ESTERO DESIGN REVIEW COMMITTEE

Public Meeting
December 17, 2014 at 5:00 PM
The Estero Recreation Center
9200 Corkscrew Palms Blvd.

APPLICANT:	**Marriot at Coconut Point**
Location of Project:	Coconut Point DRI
Presented by:	Tom McLean – Hole Montes Associates

LANDSCAPE PLANTING PLAN

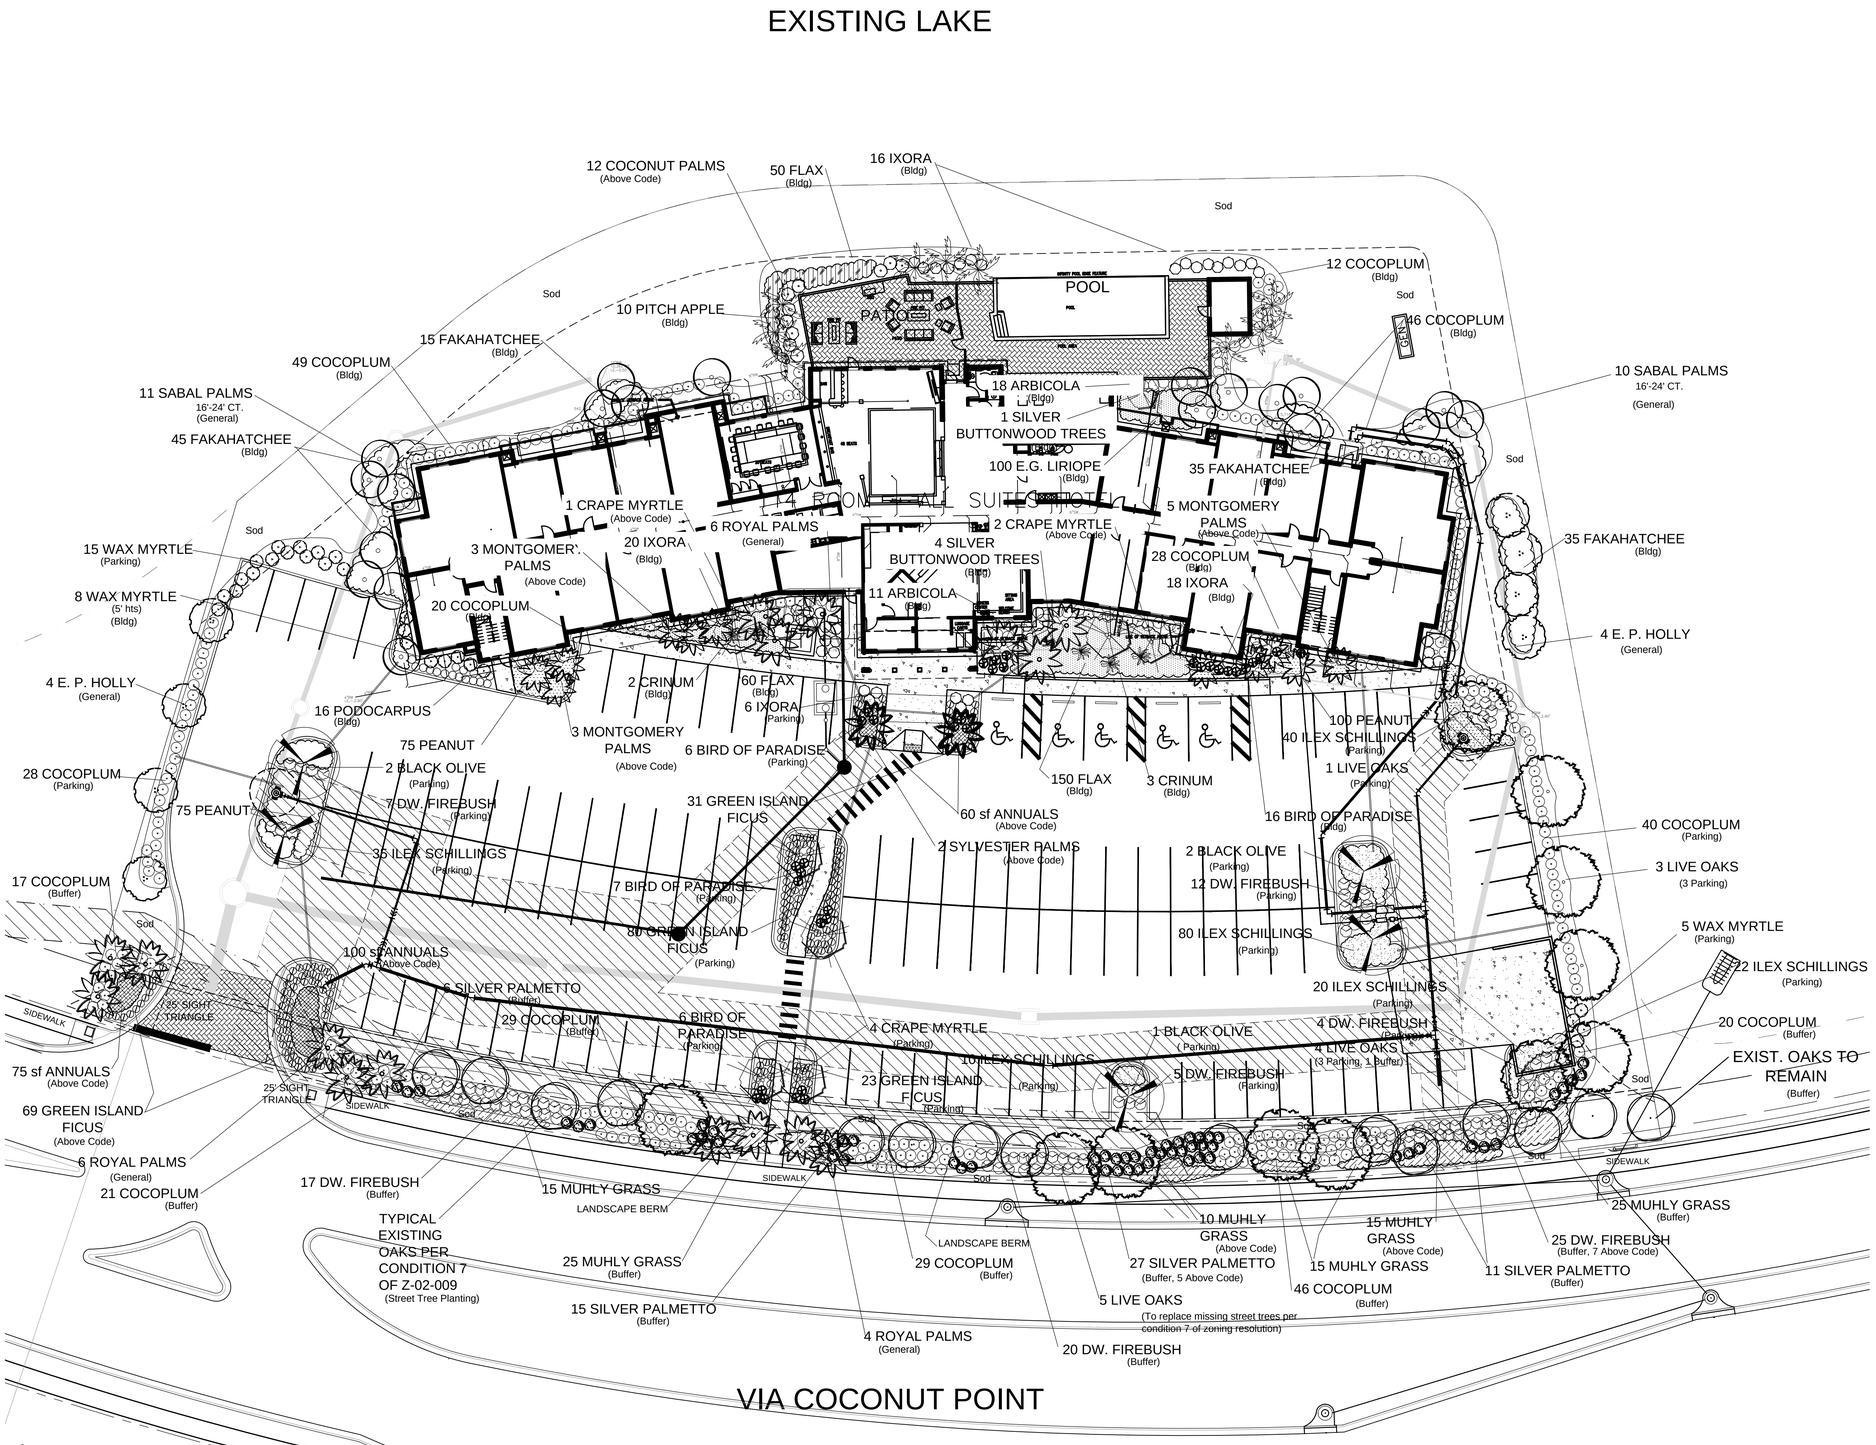
EDRC/Public Responses – Landscape Architecture
Greg Diserio, Landscape Architect presented the Landscape Design. All noted that the design was in compliance and exceeds required materials to buffers with added berming in front of the parking area to better shield the parking from the adjacent Via Cocount Point. Some material was added with larger heights mixed with smaller species to create a more human scale and transition for the pedestrian. EDRC specifically thanked the Applicant for increasing the density of the front buffer as committed to during public presentations to the ECPP. The buffer widths are 15' street tree planning buffer rather than 20' per the Coconut Point DRI.

The EDRC/Public asked about the dry detention area north of the project as being a current eye sore… if the Applicant or if Simon was going to increase or do something…..south edge also… Nothing was assured or resolved in this matter as it is off of the Aplicant's property.
